# VKMA 01130 / 01275

## Technical Bulletin - February 2012

SKF kit replacement: VKMA 01275 is replaced by VKMA 01130

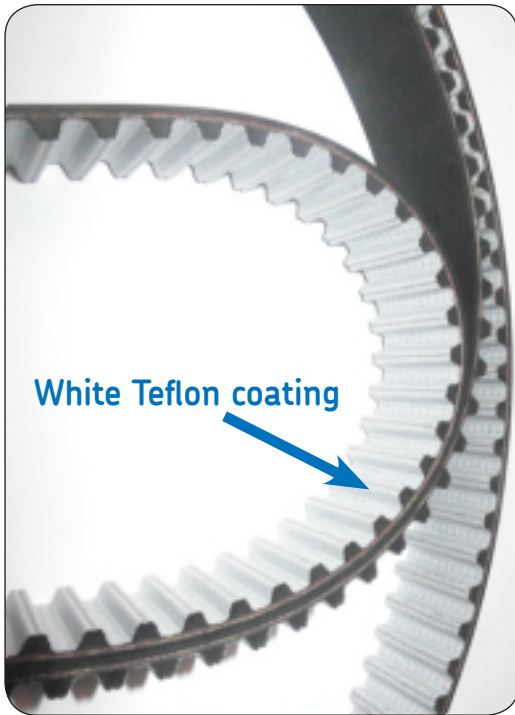
In accordance with OE specifications, the difference between the SKF timing belt kits VKMA 01130 and VKMA 01275 is the belt - both belts have same physical dimensions, but a different construction.

In-line with the OE belt material change, the belt included in the VKMA 01130 kit has been manufactured with a stronger construction. Today, car makers only use this unique, reinforced belt in the kits - therefore, SKF has also superseded the VKMA 01275 kit with VKMA 01130.

With this OE evolution and specification change, the belt material has been modified and now includes a Teflon coating.

The Teflon coating/design ensures a stronger resistance and extends the timing belt kit change interval from 90,000 to 120,000 km (or 5 years, whichever is soonest).
